CITY OF DALLAS
LANDMARK COMMISSION
Monday, February 4, 2019
AGENDA

1. 1910 PACIFIC ST
Harwood Historic District
CA189-210(LC)
Liz Casso

1. Replace brick pavers with grey tile on north and south patios. – Approve – Approve drawings dated 2/4/2019 with the finding the proposed work meets the standards in City Code Section 51A-4.501(g)(6)(C)(ii).
2. Install exterior lighting on north and south patios. –

SECTION - THROUGH COURTYARD AT PACIFIC AVE.
SCALE: 3/8 INCH = 1 FT. - 0"

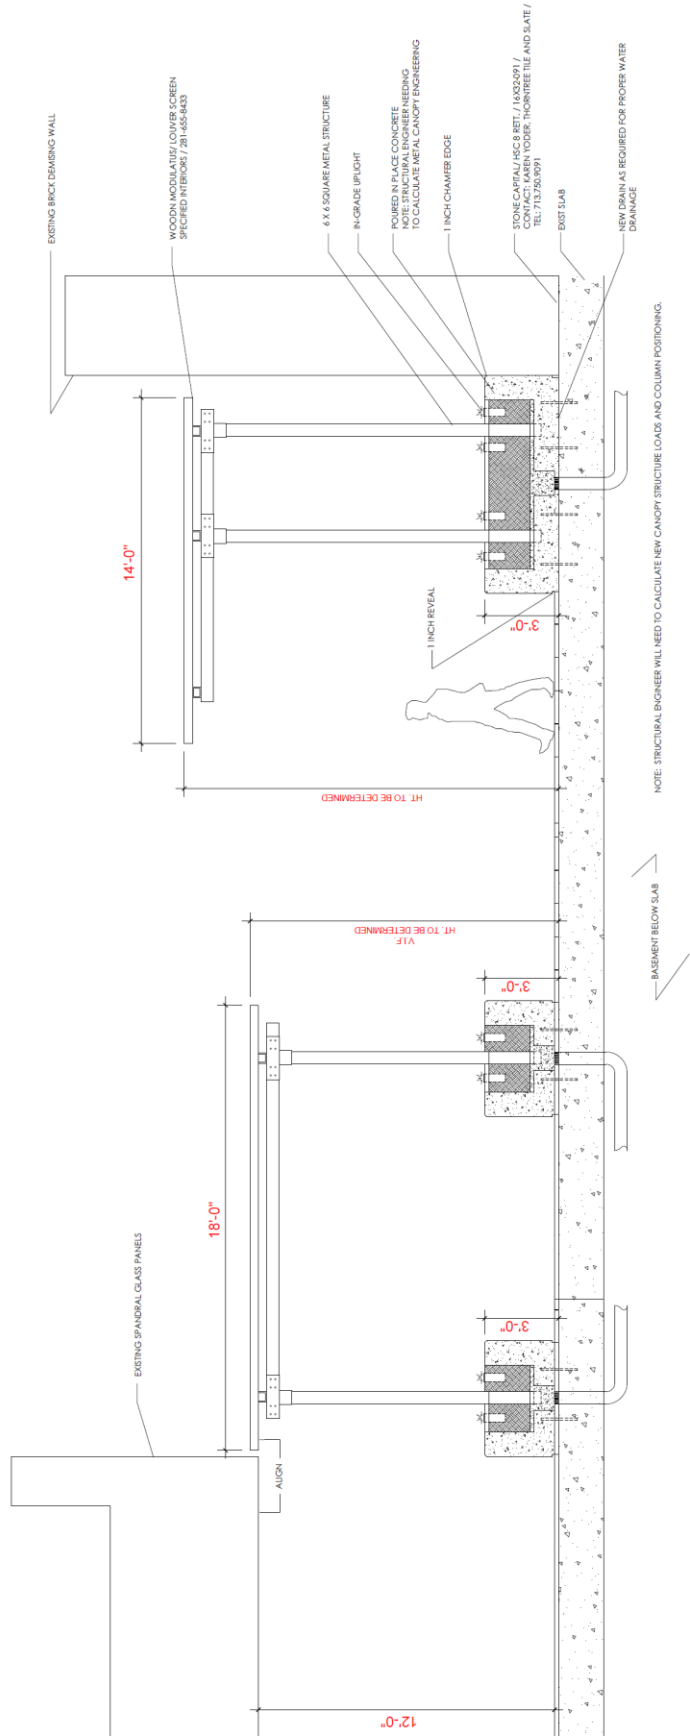
Approve submittal w/ condition to reuse/match existing brick on planter walls in lieu of architectural concrete.

- 4) Reconstruct existing brick planters on north patio. – Approve with condition – Approve drawings dated 2/4/2019 with the condition that the planters be clad in salvaged brick from the original planters, with the finding the proposed work meets the standards in City Code Section 51A-4.501(g)(6)(C)(ii).

Proposed elevations.

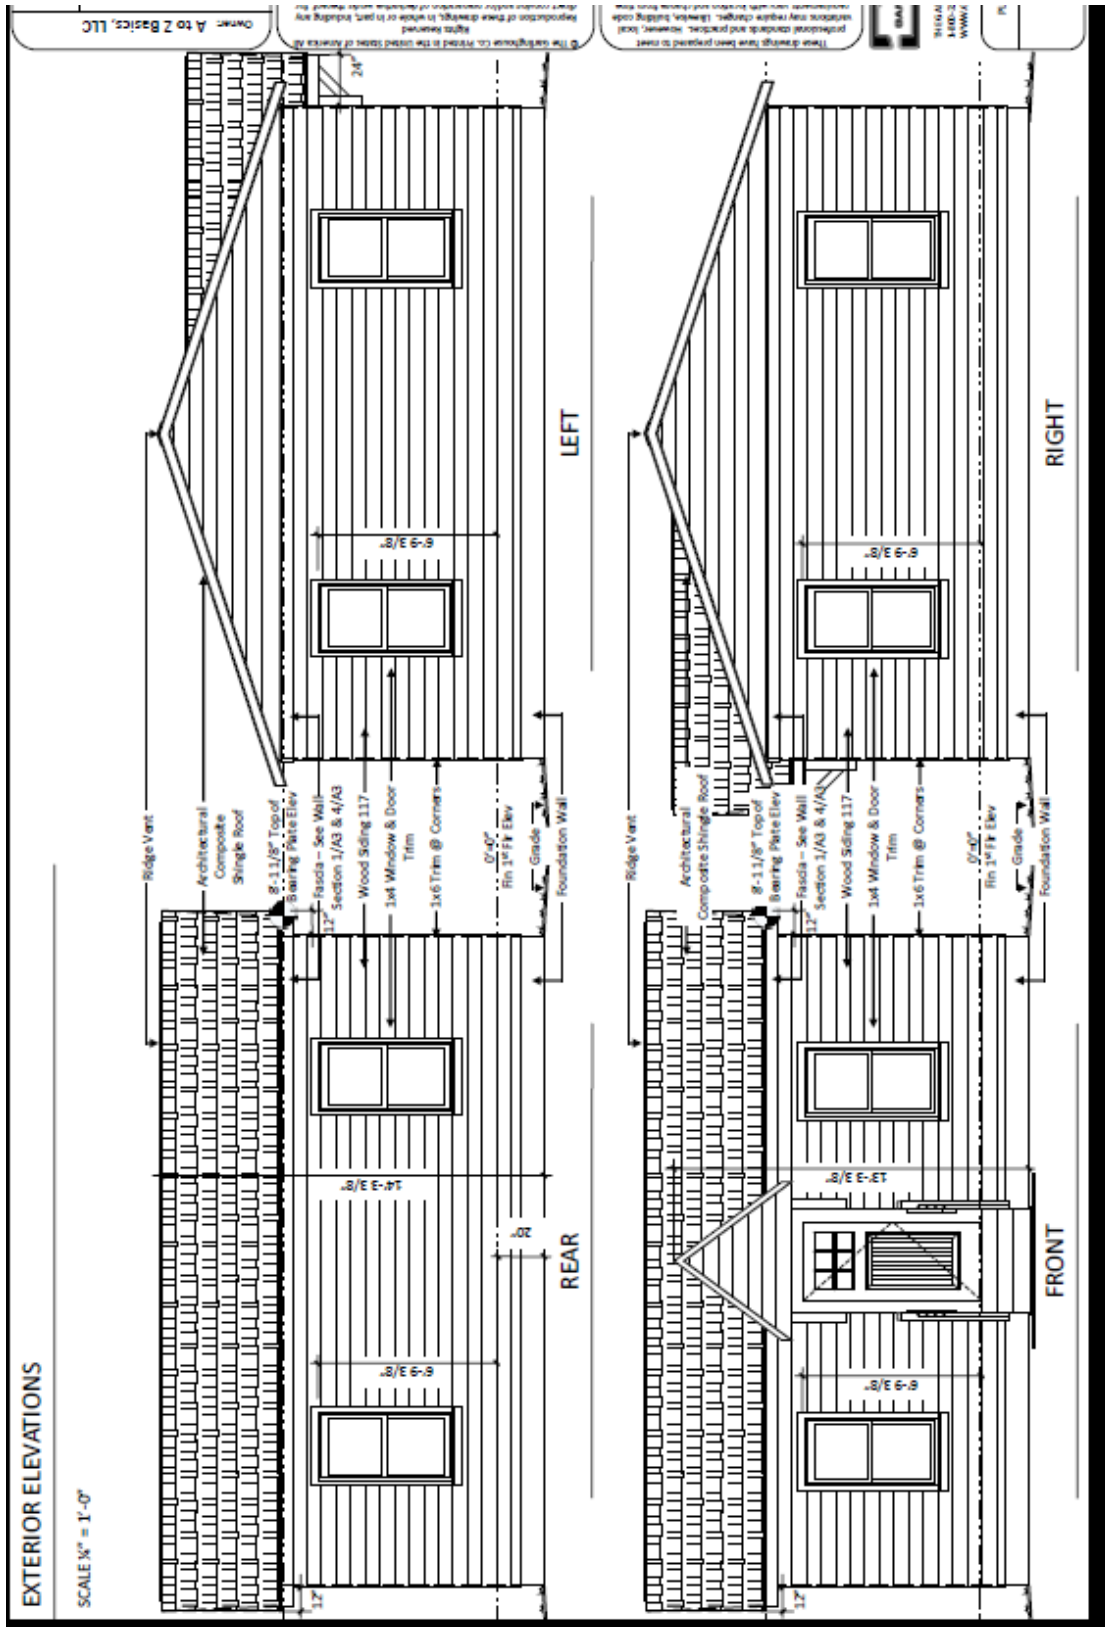
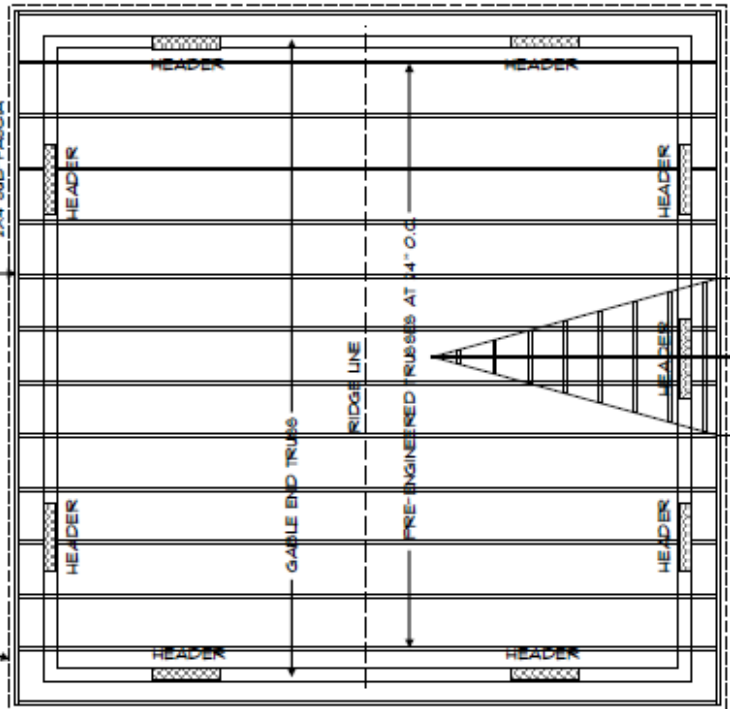
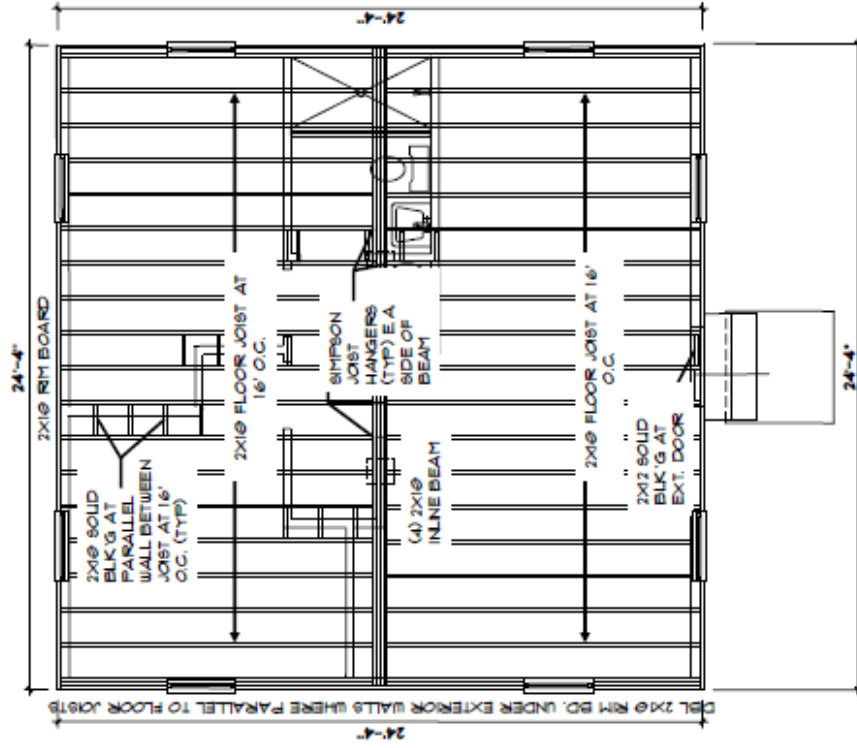
*Comment: EXTEND ROOF LINE TO OVERHANGY FRONT
AND BACK ELEVATIONS TO MATCH WHEATLEY PLACE
ARCHITECTURE.*

Comment: CHANGE TRIM COLOR TO MINTY/PASTEL COLOR.

Illustration of proposed door.

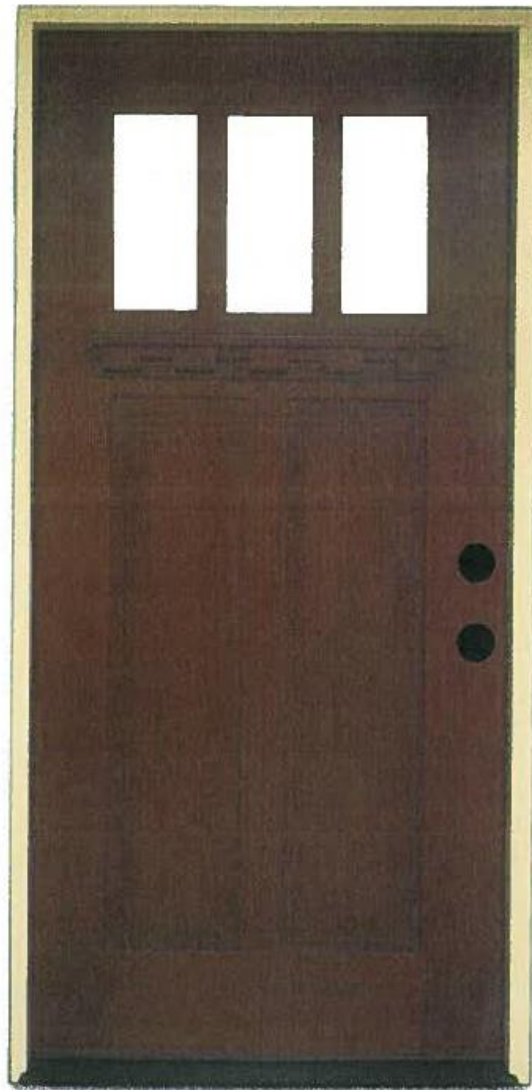
o PROVIDE CUT SHEET w/ DIM + WOOD SPECIES
SELECTIONS LOOKS GOOD / CALL OUT STAIN

Replace secondary front door with Craftsman style wood door – Approve – Approve door specifications dated 2/4/19 with the finding the work is consistent with preservation criteria

Request #s 2 and 3 – Photo submitted by applicant showing current vinyl siding and cornice.

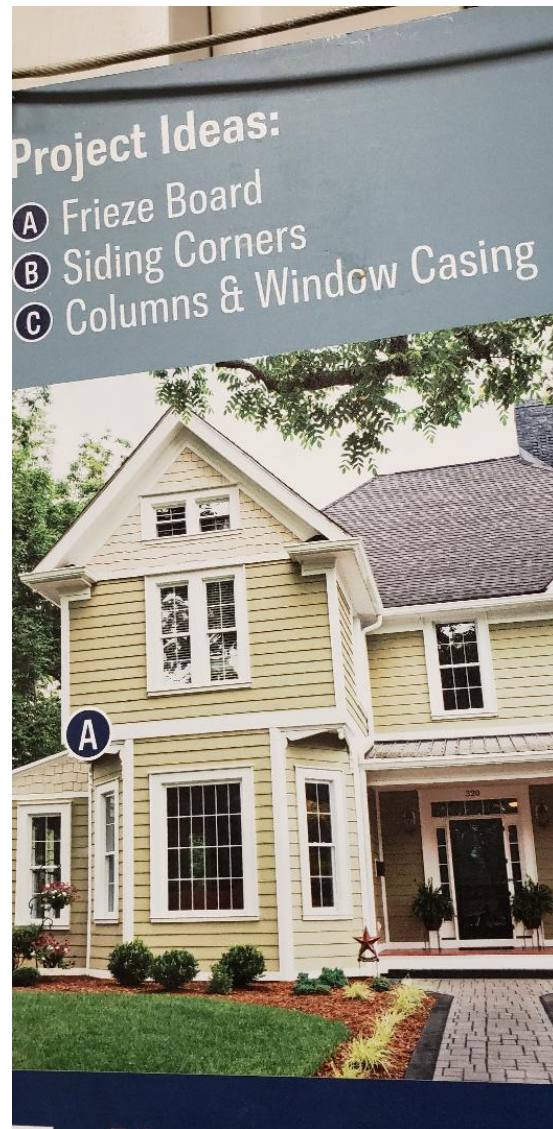
1. Install double door on side elevation - No quorum; comments only. Please provide drawings and specifications showing the remodel design and scope of project.
2. Replace vinyl siding with new vinyl siding - No quorum; comments only. Please provide drawings and specifications showing the remodel design and scope of project.
3. Replace cornice on all elevations - No quorum; comments only. Please provide drawings and specifications showing the remodel design and scope of project.

3. Replace cornice on all elevations. – Approve with conditions – Approve proposed work with the condition that cornice material is wood with the finding the work meets the standard in City Code Section 51A-4.501(g)(6)(C)(ii).
